P&WC S.B. No. 28408

TURBOSHAFT ENGINE
RGB FRONT HOUSING ASSEMBLY - MODIFICATION OF

PW206C

Summary: The front housing assembly can be modified to a PW207D1/PW207D2 engine

Reduction-Gearbox Front Housing Shoulder Pin - Removal of Figure 1

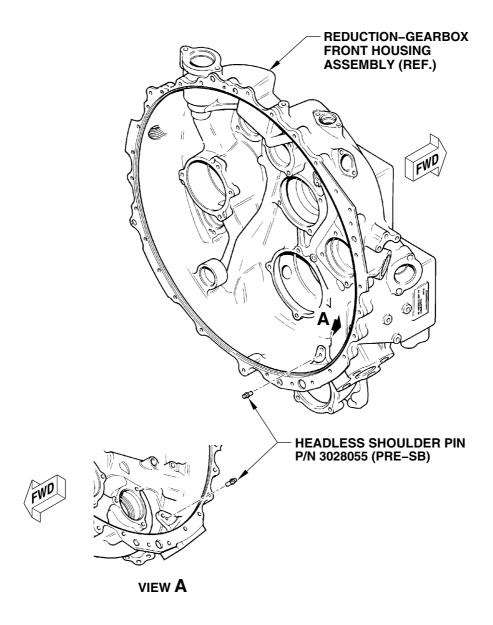
- A. Remove the parts in the Old P/N list in Para. 2.C., Material Information, in accordance with the overhaul manual instructions as follows:
 - Ref. OHM 72-11-00, REDUCTION GEARBOX DISASSEMBLY.
- B. Review the history of original front and rear housing installed on the PW206C engine model.
- C. Make sure the RGB front housing and rear housing are matched set as per SB28362.
- D. Make sure the RGB front and rear housing assembly was overhauled in accordance with P&WC CIR manual (P/N 3040877).
- E. Remove the two shoulder pins P/N 3028055 from the RGB front housing assembly (Ref. Fig. 1).

Housing Vibration Peening - Rework of Figure 2

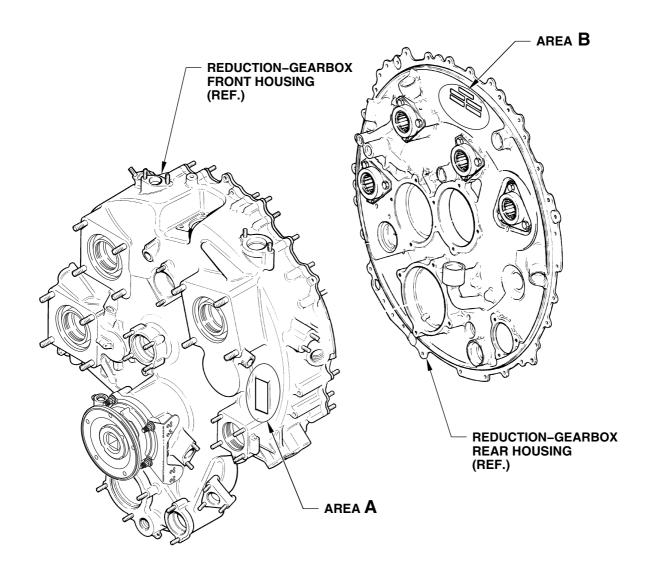
F. Use the vibration peening procedure, 0.003 to 0.006 in. (0.08-0.15 mm) deep, to identify the front and rear RGB housing assembly matched set as follows (Ref. Fig. 2):

- (1) Put a line across the old P/N 3044637-01 on the RGB front housing assembly. Use the vibration peening procedure, 0.003 to 0.006 in. (0.08-0.15 mm) deep, and write the new P/N 3071975-01 in the same area.

- (2) For front and rear housing assemblies, use vibropeen and put a line across the existing match set identity number with prefix "MX" followed by the six digit PW206C engine serial number in Areas A and B.

- (3) Vibropeen front housing with new identity number in Area A with prefix "MX" followed by the six digits PW207D1 or PW207D2 engine serial number.
- (4) Vibropeen rear housing with new identity number in Area B with prefix "MX" followed by the six digits PW207D1 or PW207D2 engine serial number.
